**UNITED STATES DEPARTMENT OF COMMERCE
Patent and Trademark Office**

Office Action Summary

Application No.
09/653,169

Applicant(s)
SAKAMOTO, ET AL

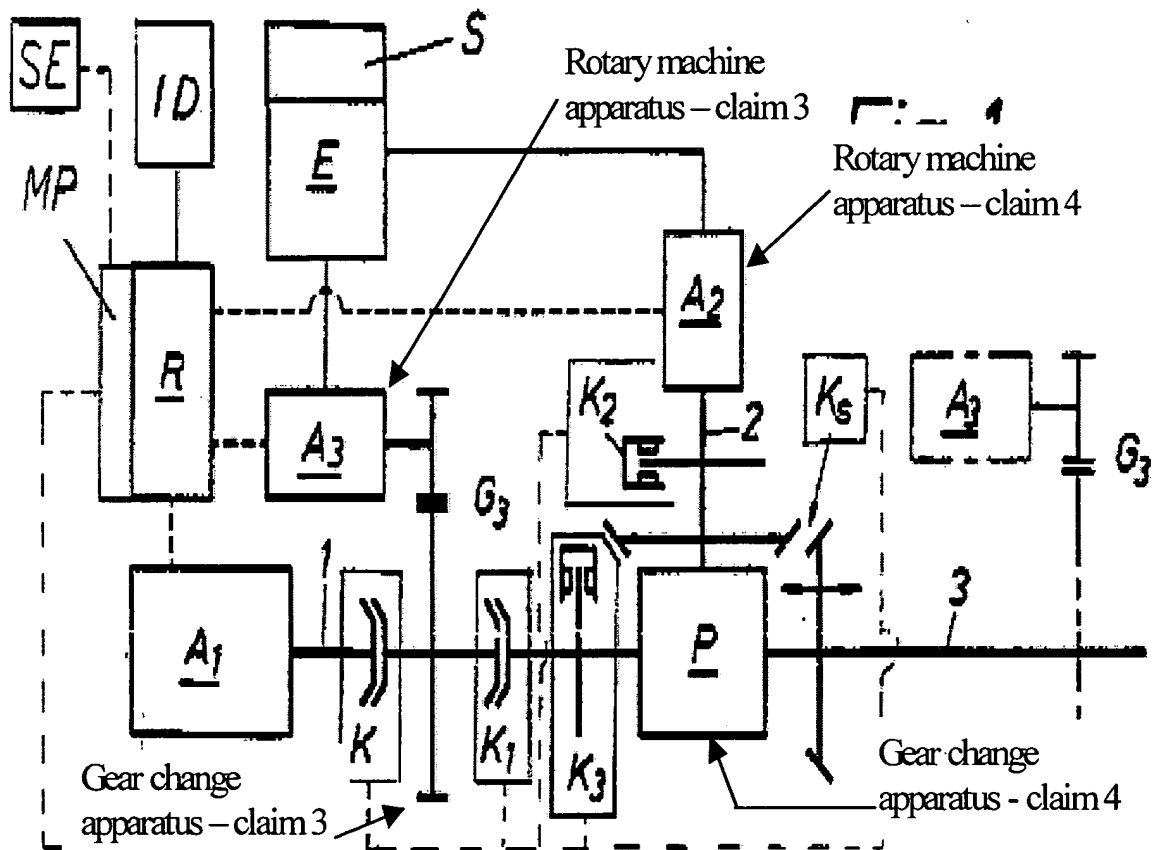
a gear change apparatus (see sketch next page) provided between said engine and vehicle drive shaft (3);

an electric rotary machine (see sketch next page and lines 38 and 39 of column 3 of Kriegler) connected to an output shaft (1) of said engine and said vehicle drive shaft via said gear change apparatus (Figure 1);

wherein a gear connected to the output shaft of said electric rotary machine meshes with a larger diameter gear in an engine side input shaft of said gear change apparatus (claim 3 - see sketch next page); and

wherein the output shafts of said engine and said electric rotary machine are provided separately (claim 4 - see Figure 1), and;

gears respectively mounted on said two shafts for transmitting the power of the output shaft of said engine and the output shaft of said electric rotary machine directly engage with each other (claim 4 - see sketch below and Figures 1 and 2 of Kriegler, noting that there is a "bevel"

gear associated with P and connected with K₃ not illustrated on Figure 1, but illustrated on Figure
